ZONING BOARD AGENDA – JANUARY 26, 2026
MEETING TIME: 7:00 PM
MAIN MEETING ROOM

- 8.II. #2025-015 – Ahmed & Rebecca Sourour, 435 Navesink River Road, Block 983, Lot 3, Located In The R-220 Zone.

DATE: January 15, 2026
BOARD: Zoning Board of Adjustment and Appeals
APPLICATION: Jennifer & Alexander Rossano (#2025-030)
20 Park Way (Block 779.01, Lot 48.01)
R-45 Zone & Water Witch Club Historic District
"Planning" Variance for Building fronting upon a street not improved to Township standards

Re: 20 Park Way Variance
Alexander & Jenifer Rossano
Block 779.02, Lot 48.01
Variance Plan Application
Technical Review # 1
MTZB# 2025-30
HACE # MTZ-034

PROPOSED POOL AND CABANA
PLAN, PROPOSED CABANA
ELEVATION

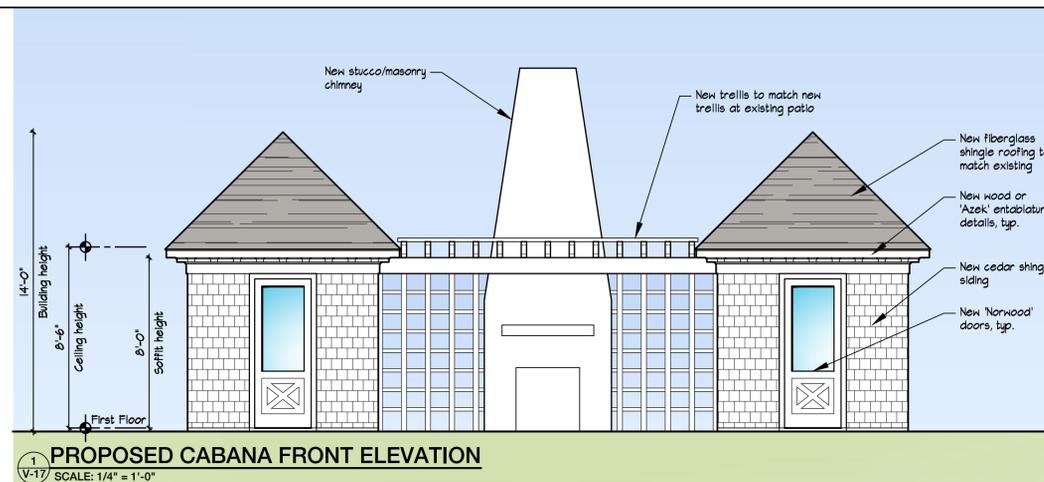
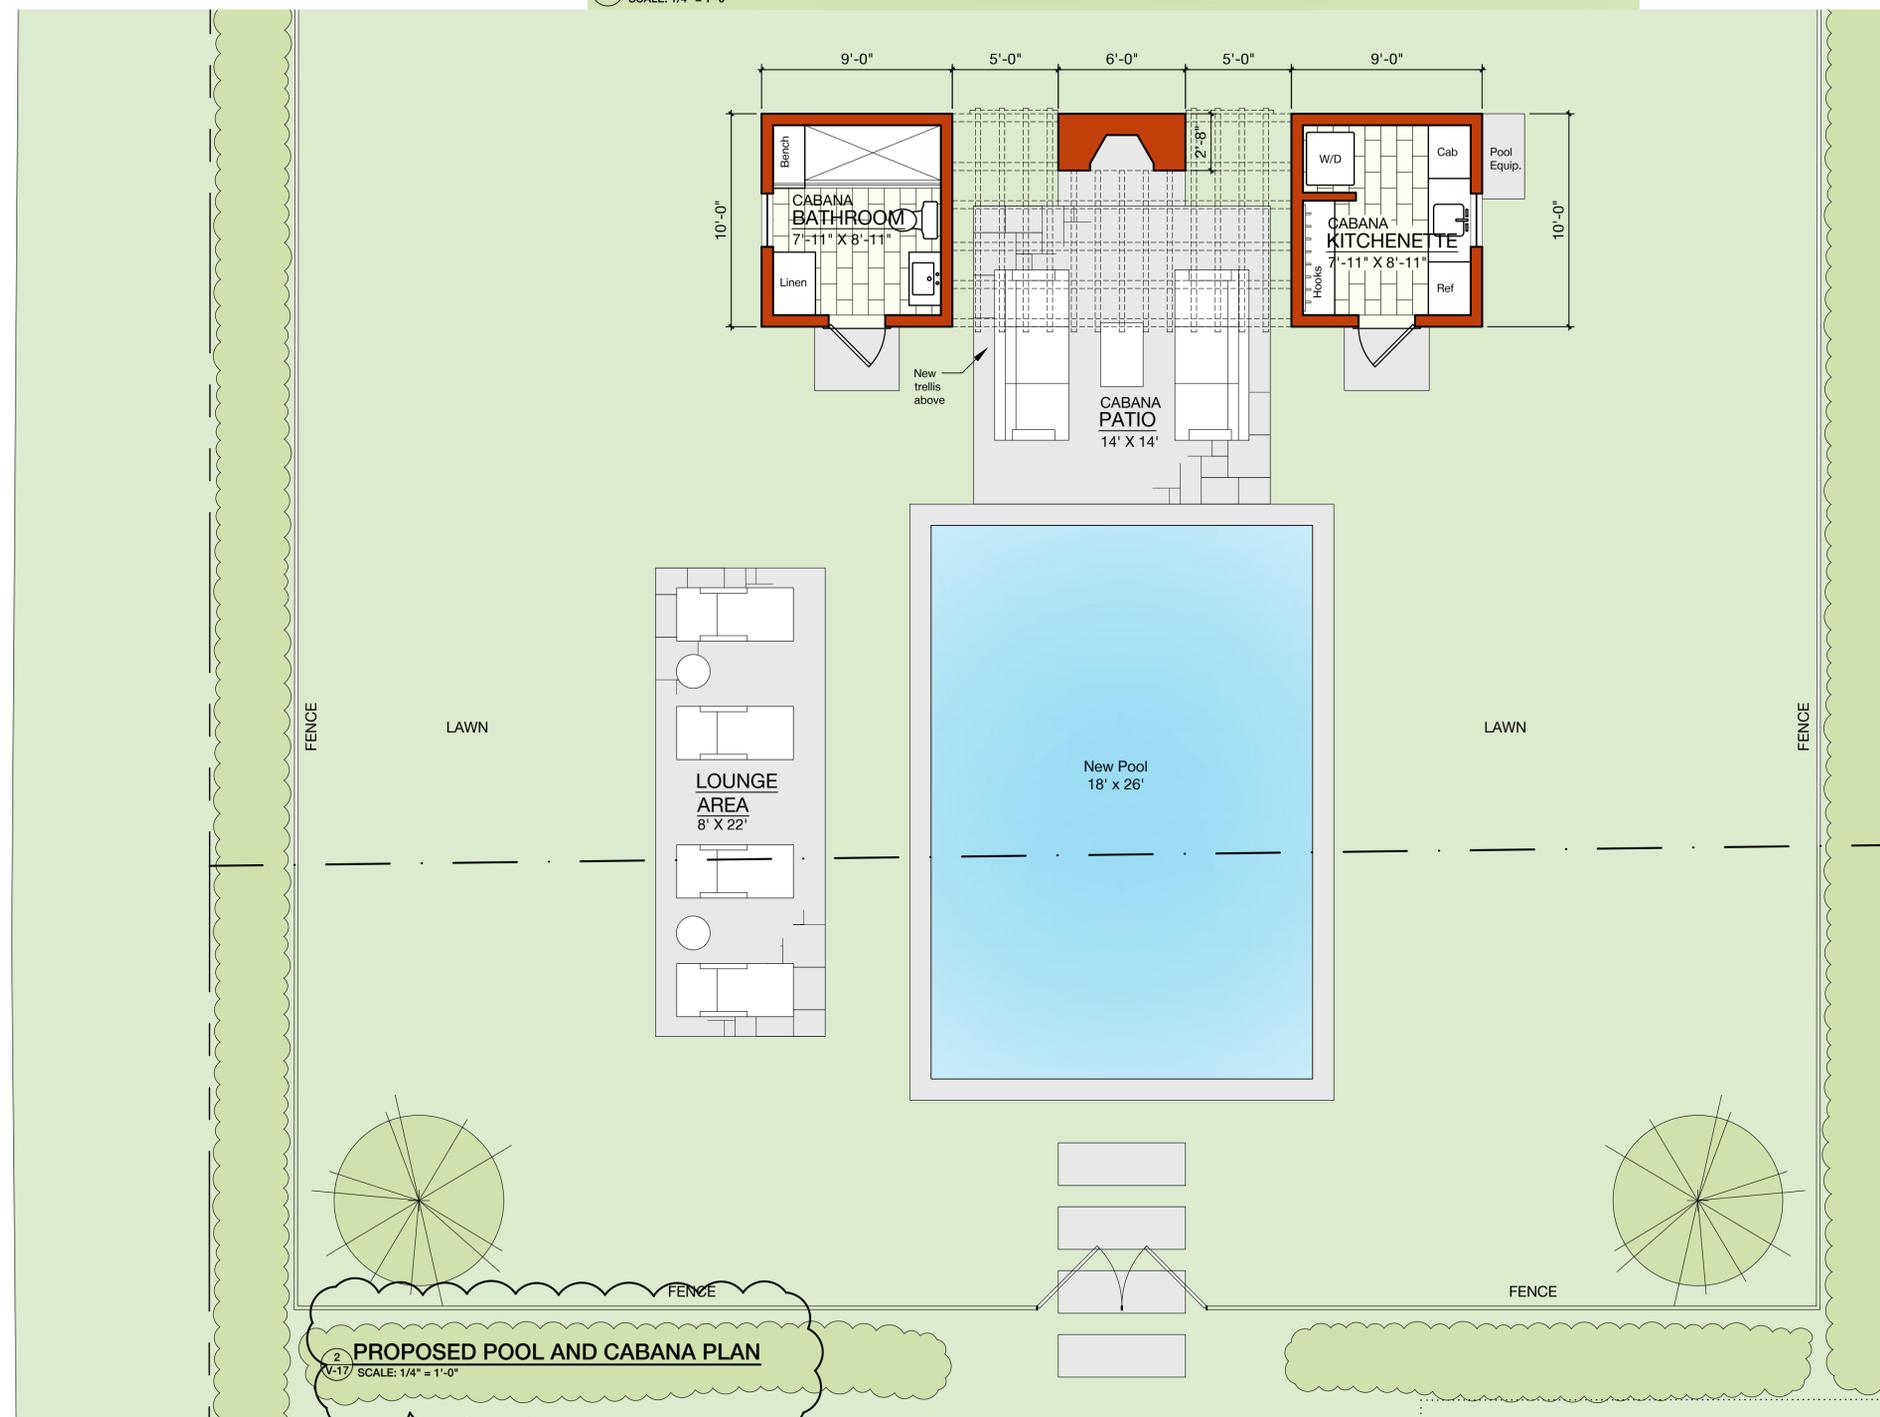
3. Cabanas – Cabanas are permitted in residential zones as per 540-203. The applicant shall submit floor plans for the proposed cabanas to ensure compliance with these regulations. **The applicant submitted floor plans for the proposed cabanas. As per the definition of “Cabana,” the following rules apply:**

1. Pool and cabana plan revised
 - a. Decreased cabana size (18 sf)
 - b. Decreased pool size (12 sf pool coping)
 - c. Removed stepping stone at pool gate (12 sf)
 - d. Relocated pool up against cabana patio
 - e. Relocated pool equipment to the side of the cabana

VARIANCE PLAN & STEEP SLOPE PLAN

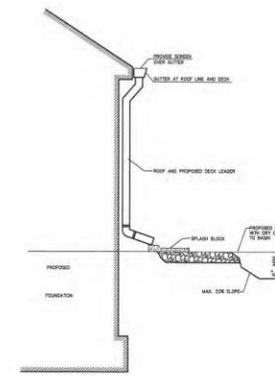
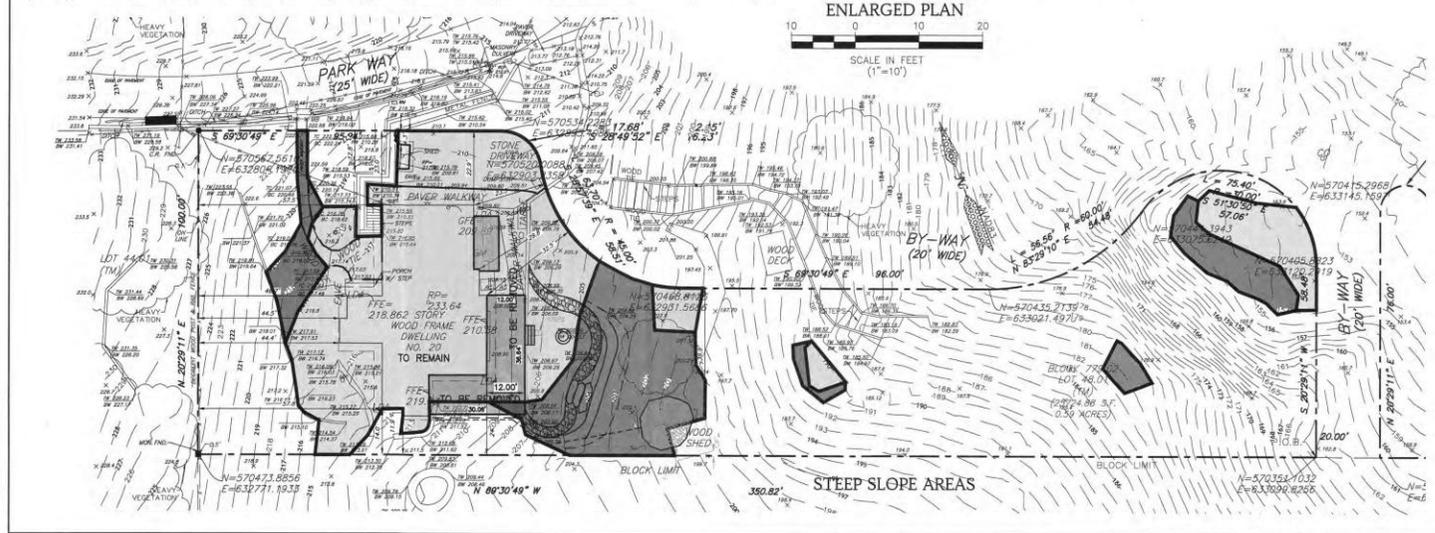
- a) The text talks about infiltration basins and the plan shows a rain garden. *This discrepancy should be explained.*
 - b) A full detail of the swale and rain garden should be provided. *Both the swale capacity and the rain garden capacity should be doubled with a 2 times factor of safety.*

- d) About a quarter of the infiltration basin is in the greater than 15% zone. We request the applicant move this area West to remove it out of the steep area. If it is not fully removed, a partial waiver will need to be *granted by the Board from the slope ordinance.*

- e) A grading plan with all elevations and contours should be submitted to the Township at a later date.
- 5) The location of gutter / leaders should be shown on the plan and be run to the street if possible.
